Low-Enriched Uranium for Potential Naval Nuclear Propulsion Applications

JSR-16-Task-013

November 2016

JASON
The MITRE Corporation
7515 Colshire Drive
McLean, Virginia 22102
(703) 983-6997

Figure 13: Approximate planned timeline for ELE-LEU in-reactor testing (four phases), development and construction of fabrication facilities, and deployment of first LEU-fueled reactor on a FORD-class carrier, shown here as the second ship (USS John F Kennedy) built in this class.

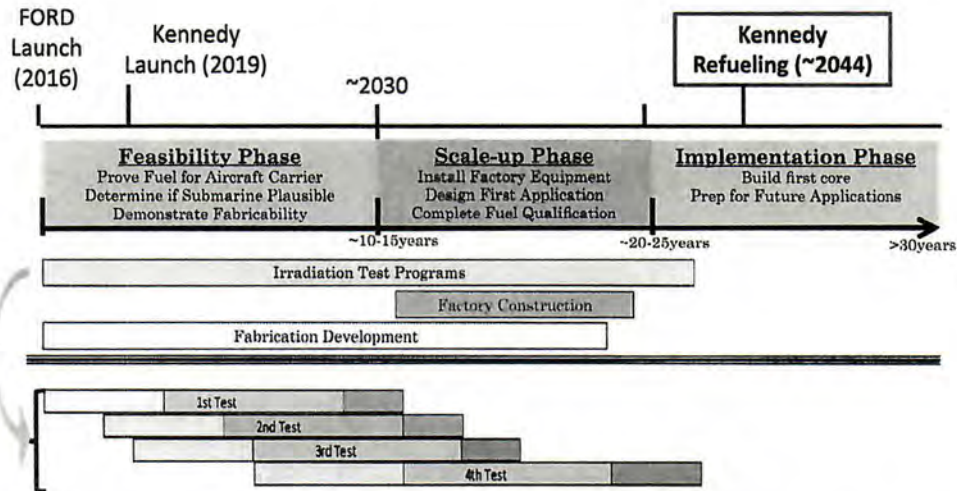
Figure 13 shows the time-line for the development of the ELE-LEU fuel of the FORD-class carriers. The irradiation test program continues for 20–25 years in four overlapping phases, each test taking of order five years of in-reactor irradiation with years before and after irradiation for specimen design, manufacturing, testing, and destructive evaluations, as illustrated in the figure. NNPP requires testing of fuel at its end of life conditions, reached after 25 years of use in the carrier core. For example, to test the fuel's ability to contain fission gases during a transient event, the integrated fission density must be brought to the end of life level.

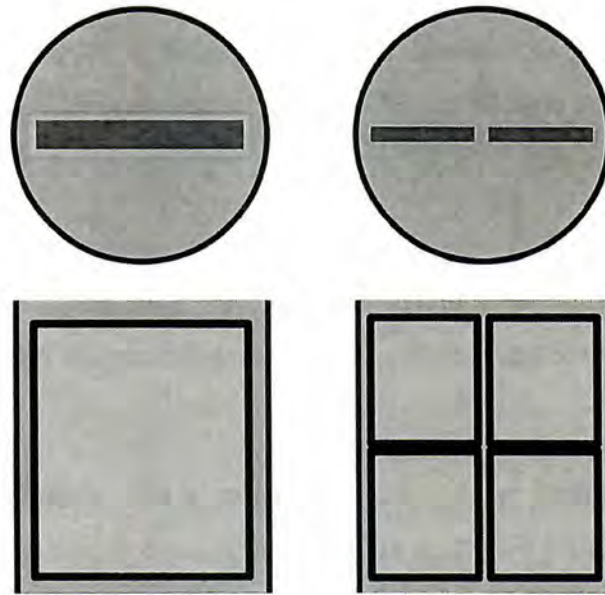
Scaled Fuel Tests A larger number of test data points in the relevant parameter space could help constrain the models used to characterize LEU fuel. The use of scaled experiments could mitigate the shortage of ATR test loops and long duration of the tests. Achieving the target burnup sooner enables more data collection in the same time interval, and changing the burnup rate means changing the power density, which changes the temperature profile, calling into question the relevance of the test.

The same conditions are obtained in a test article half the size and thickness, shown to the right in the figure, if it is subjected to four times the neutron flux and provided with sufficient cooling to have the same surface temperature (which is obtained to a good approximation by doubling the coolant flow). The energy production per unit area will be twice as high (half the fuel, four times the flux), but the resulting temperature profile will be the same because the element is only half as thick. Doubling the coolant flow compensates for doubling the heat production. Coolant inlet temperature can be modestly adjusted to achieve the desired element-surface temperature. The scaled test reaches the same burnup as the full sized article in a quarter the time, and four times as many articles can be tested in the same volume.

The scaling by a factor of two in the above example is notional: the optimal scaling factor will depend on the attainable water flow in the ATR, the number of samples in the test train, and other factors.
